TONGANOXIE PLANNING COMMISSION

a) Consideration of Preliminary Plat for Deer Creek at property generally located at the intersection of 24/40 and Smiley Road, Tonganoxie, KS 66086

DEER CREEK ADDITION NO. 1
PRELIMINARY PLAT
CITY OF TONGANOXIE
LEAVENWORTH COUNTY
KANSAS

**DEER CREEK ADDITION
 DRAINAGE AREA MAP, PROPOSED CONDITION
 FIGURE 2- MARCH 4, 2022**

DEER CREEK ADDITION
DRAINAGE AREA MAP, EXISTING CONDITION
FIGURE 1- NOVEMBER 23 , 2021

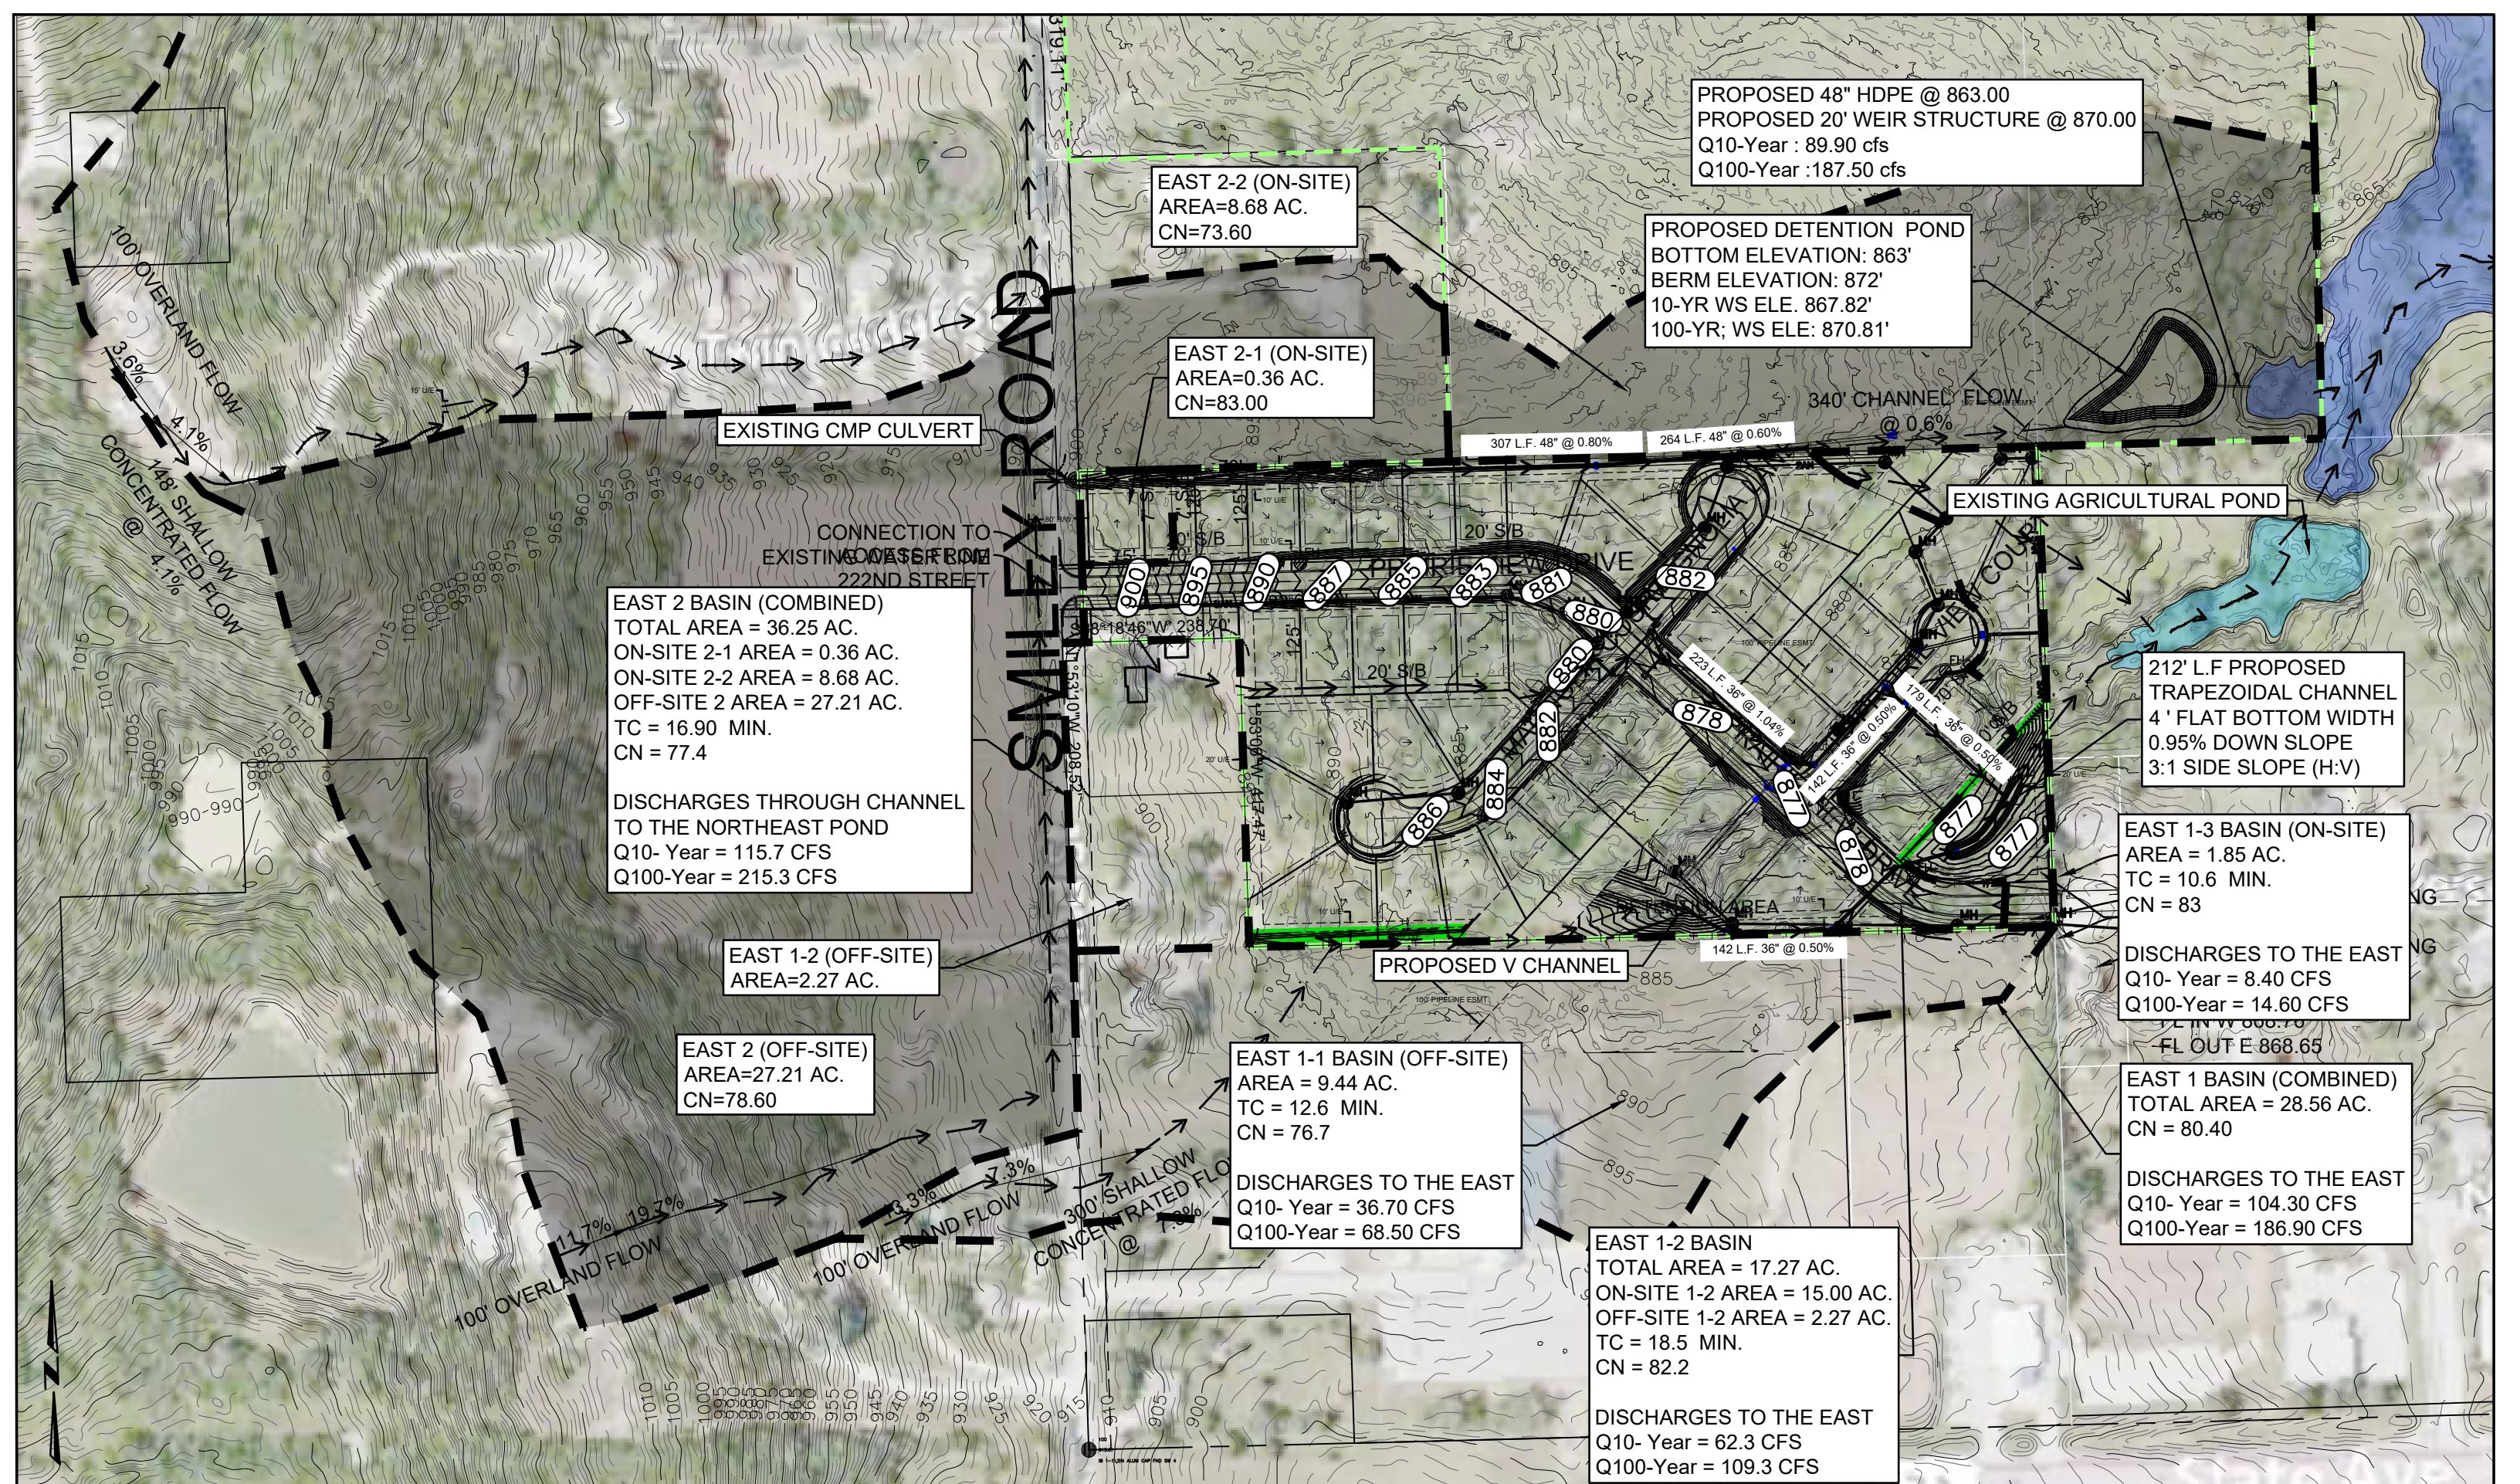
- The existing flows to discharge points should not be exceeded after development. Provide existing and proposed flows to each discharge point.
- It appears that water is being rerouted from Existing East 1 Basin (Offsite 1-2) to the East 2 Basin as part of the project. The memo should detail this and explain why this is occurring.

- Watershed Maps
 - The boundaries of the watersheds and sub-watersheds are unclear. Provide a map that clearly delineates the location of the watersheds and sub-watershed.

Appendix C: Detention Pond Analysis

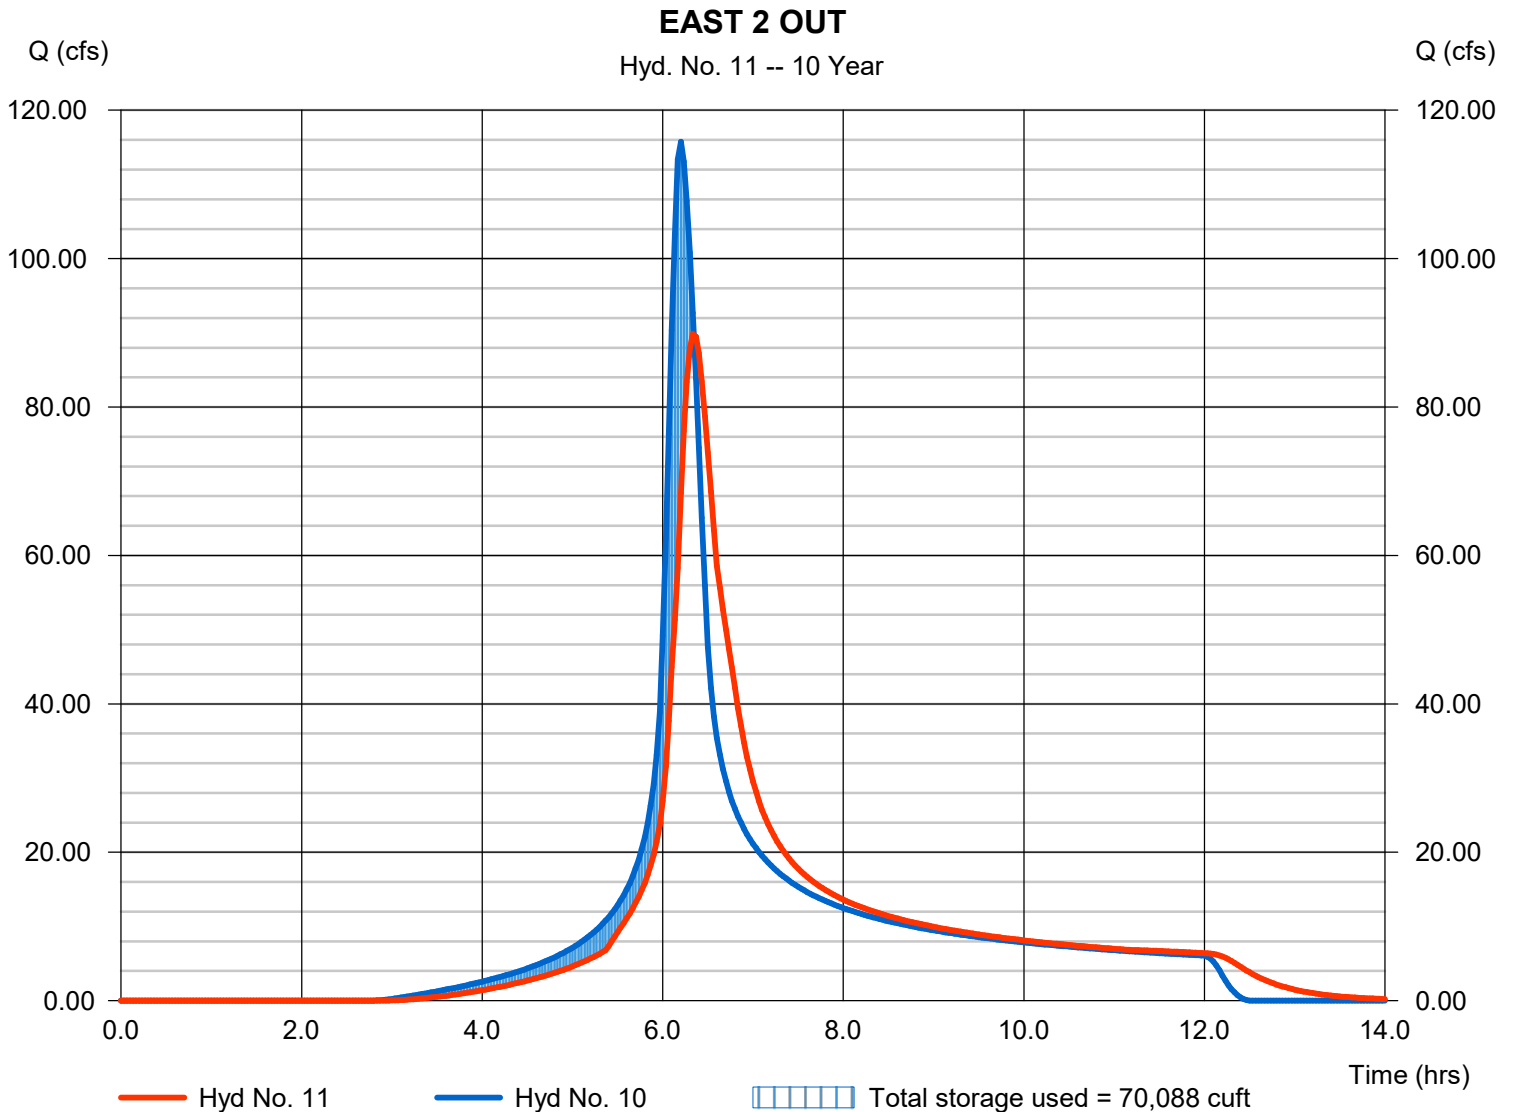
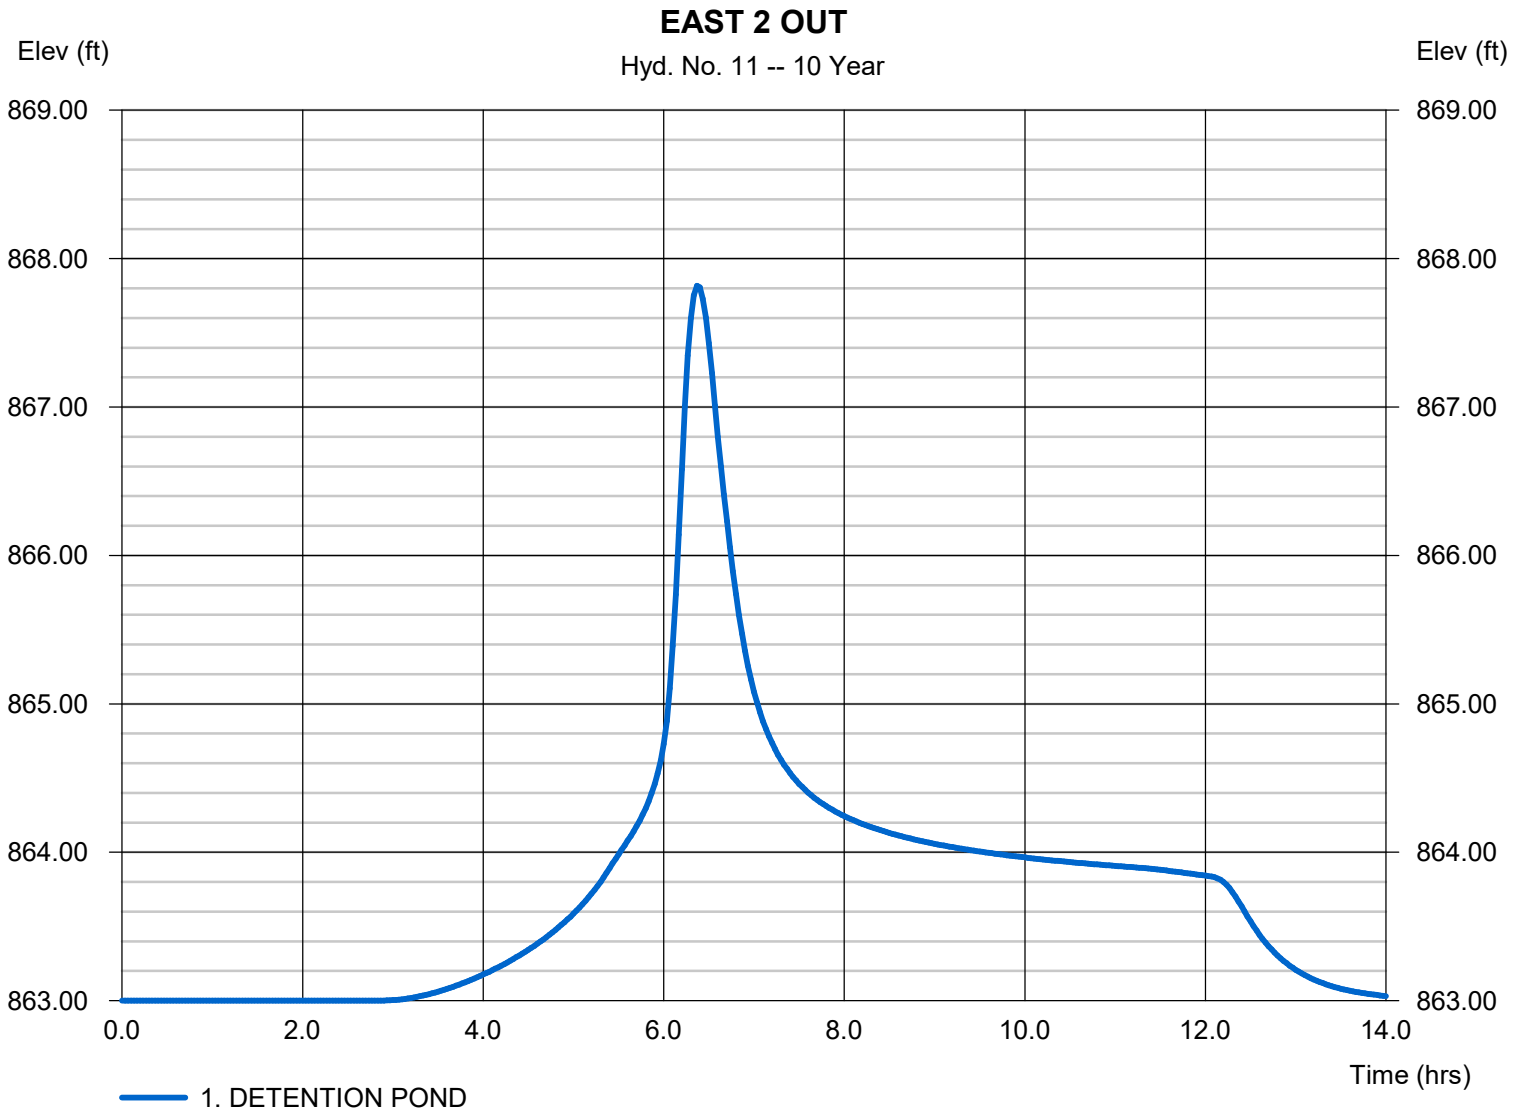
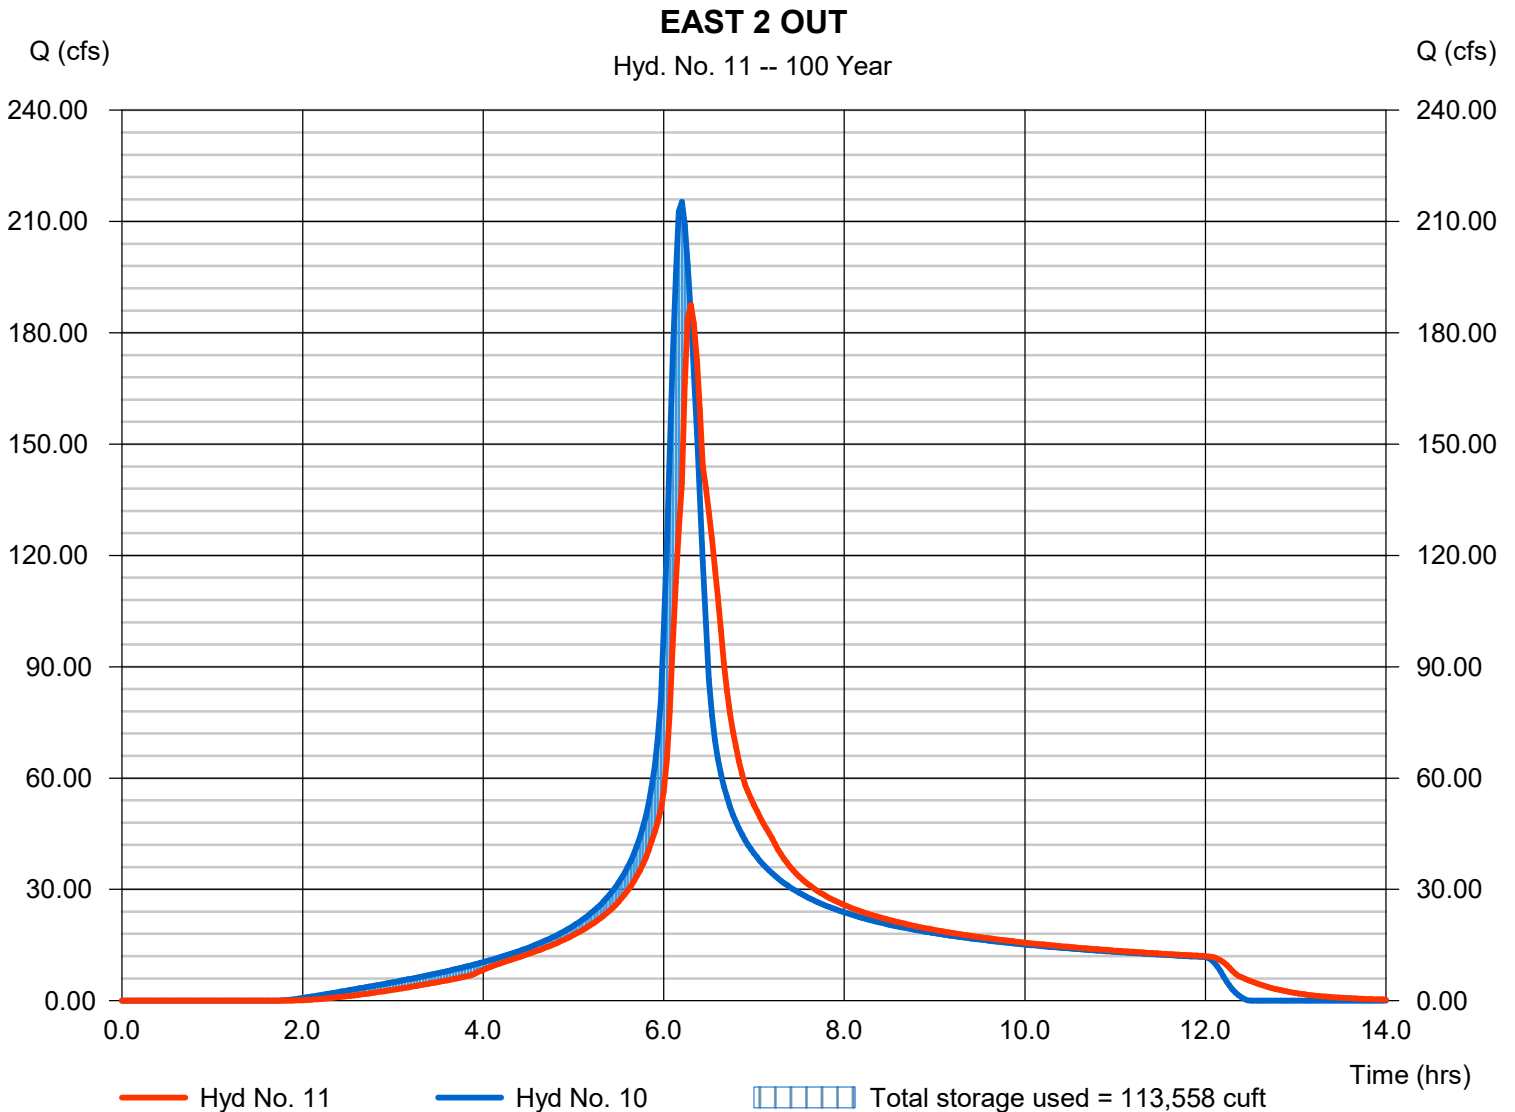
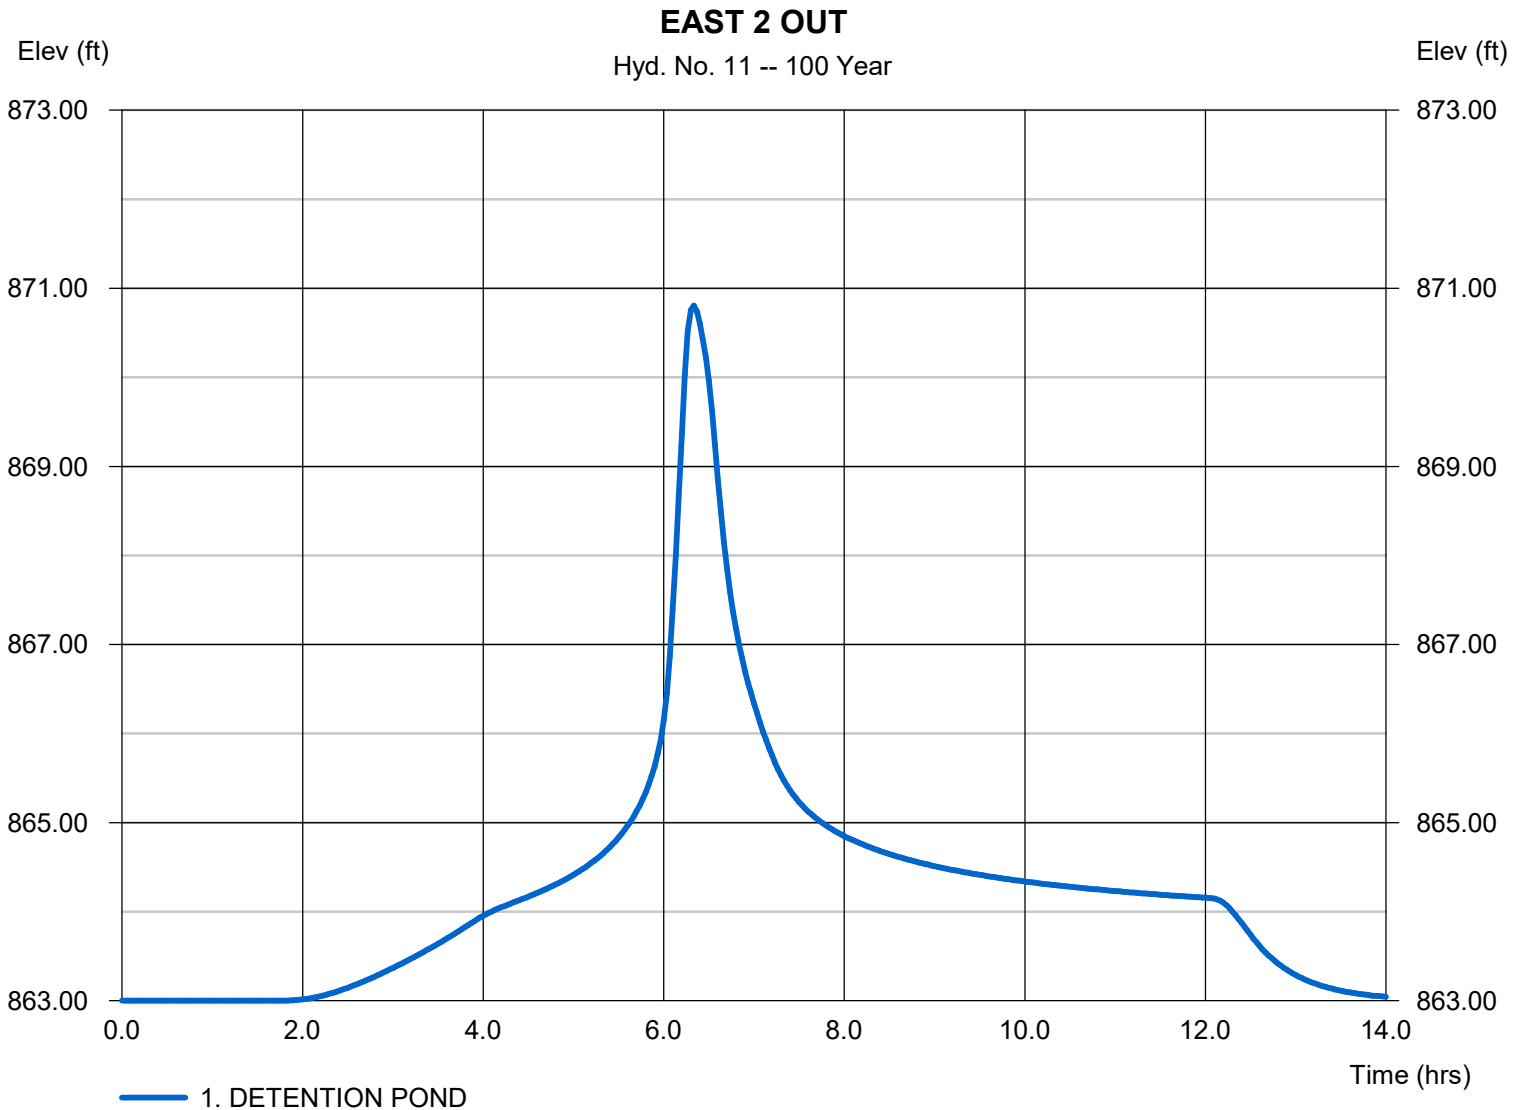
- The inputs for the detention pond are incorrect. The stage/storage table should be updated to provide storage areas at 1’ intervals. With a minimum bottom slope of 1% and the flowline out elevation of 863.0, the area at 863 should be 0.

- Provide a detail of the detention basin and outlet structures.
 - Provide discharge velocity calculations and erosion protection, if needed.

- Provide calculations for an emergency spillway meeting the following requirements:
 - F. **Emergency Spillways:** The emergency spillway may either be combined with the outlet works or be a separate structure or channel meeting the following criteria:
